UN Regulation No. 79 (Steering equipment):**Automatically Commanded Steering Function****Proposal for a Supplement to the 03 series of amendments to
UN Regulation No. 79 (Steering equipment)****Submitted by the experts from the International Organization of Motor
Vehicle Manufacturers and the European Association of Automotive
Suppliers***

The text reproduced below was prepared by the experts from the International Organization of Motor Vehicle Manufacturers (OICA) and the European Association of Automotive Suppliers (CLEPA). It is based on informal document GRVA-07-43. The changes to the current text of the Regulation are marked in bold for new or strikethrough for deleted characters.

2.1.2.1. General

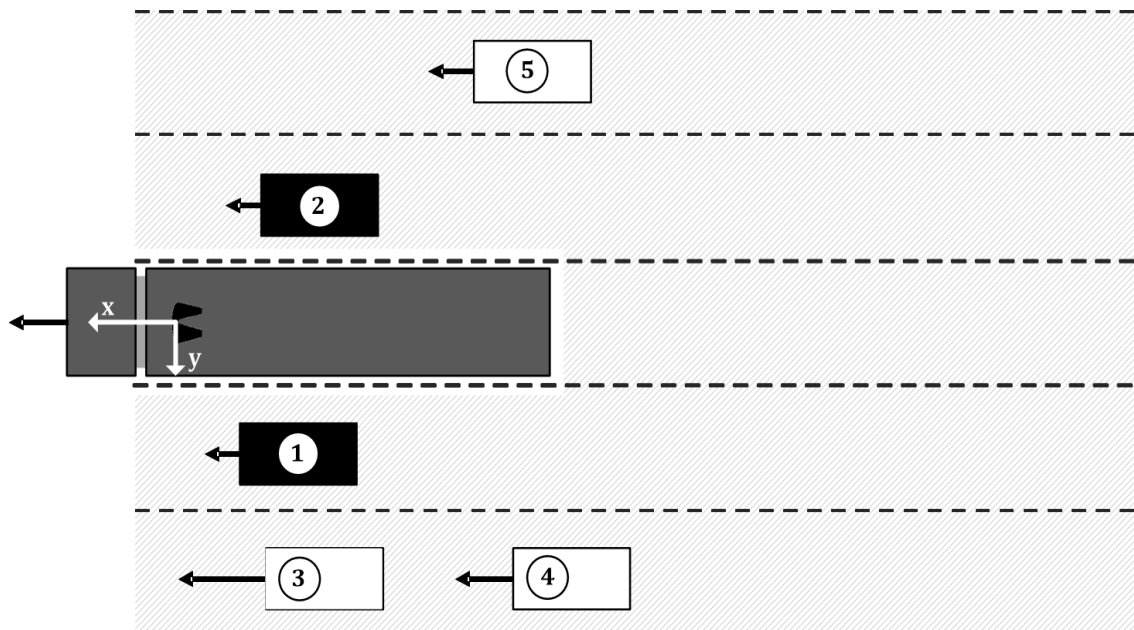
IMPORTANT — If ISO 11992-1 is used as a data link and physical layer only one trailer (towed vehicle) can be supported due to bandwidth overload of the CAN bus between towing and towed vehicles.

The towing vehicle shall not rely on any sorting of the objects communicated by the towed vehicle.

2.1.2.3. Objects behind the towed vehicle

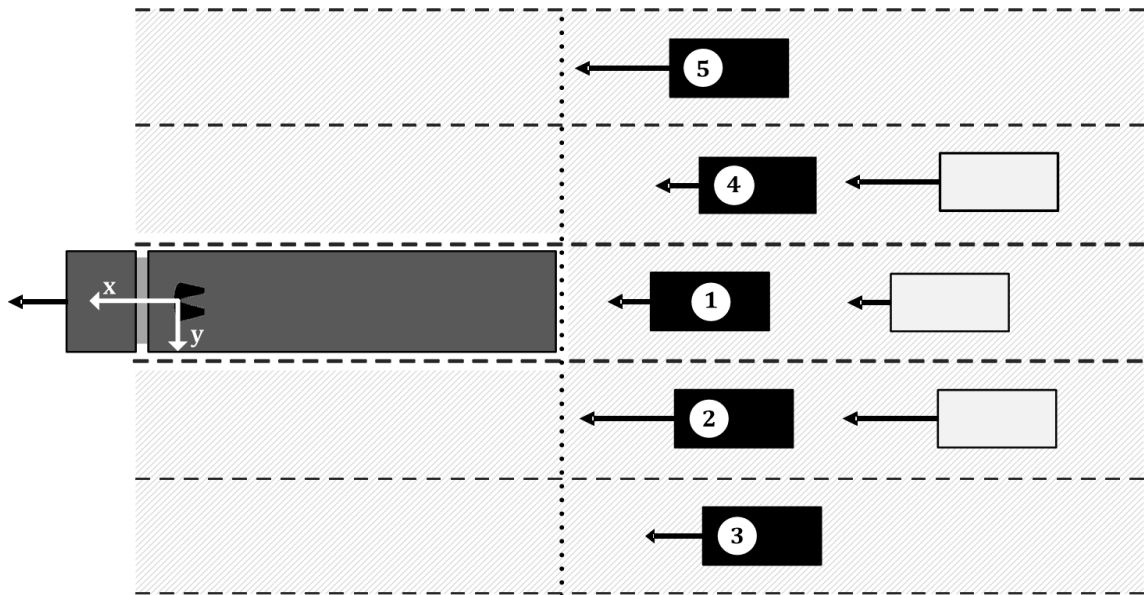
The area behind the towed vehicle is split into five ranges. From each range an object shall be selected, if present. If the absolute velocity of the towed vehicle > 10 km/h only moving objects shall be selected. An object is moving if its absolute velocity is not zero. The five ranges are specified by the lateral position relative to the towed vehicle:

- (a) $-0.5 \times w - 7 \text{ m} \leq y < -0.5 \times w - 3.5 \text{ m}$
- (b) $-0.5 \times w - 3.5 \text{ m} \leq y < -0.5 \times w$
- (c) behind the towed vehicle
- (d) $0.5 \times w < y \leq 0.5 \times w + 3.5 \text{ m}$
- (e) $0.5 \times w + 3.5 \text{ m} < y \leq 0.5 \times w + 7 \text{ m}$

Where y is the lateral position [m] and w is the width [m] of the towed vehicle.
